star bulletin

Date: November 13, 2014
Order No.: T-B-28.00/13
Group: 28

SUBJECT: MY2014 to Present, Model W/X166
Transfer Case Breather Design Change

Figure 2. Former vent blocked off in new transfer case

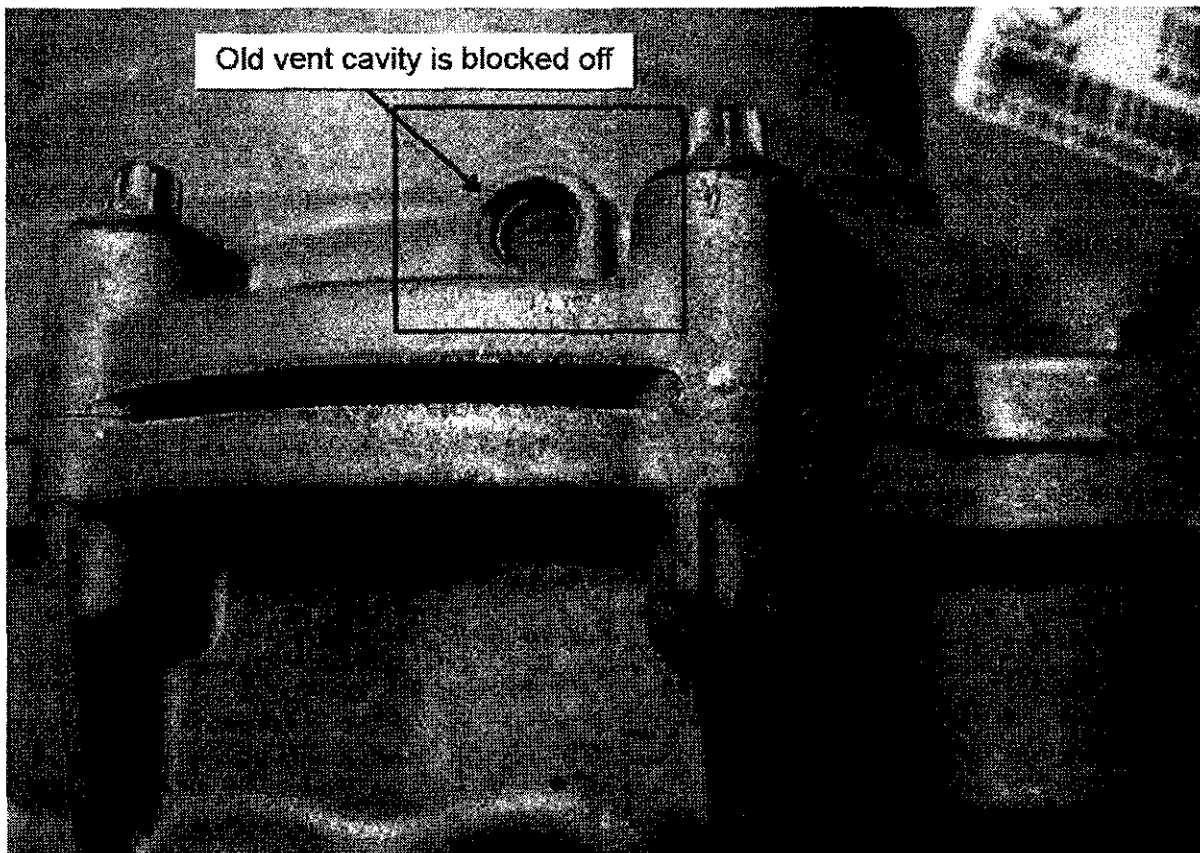
The 166 single speed transfer case breather vent is no longer installed on the top of the transfer case. An open vent has been added to the design near the input of the transfer case (Figure 1). The original vent location is now blocked off (Figure 2). Transfer cases should not be replaced for missing vents in this case.
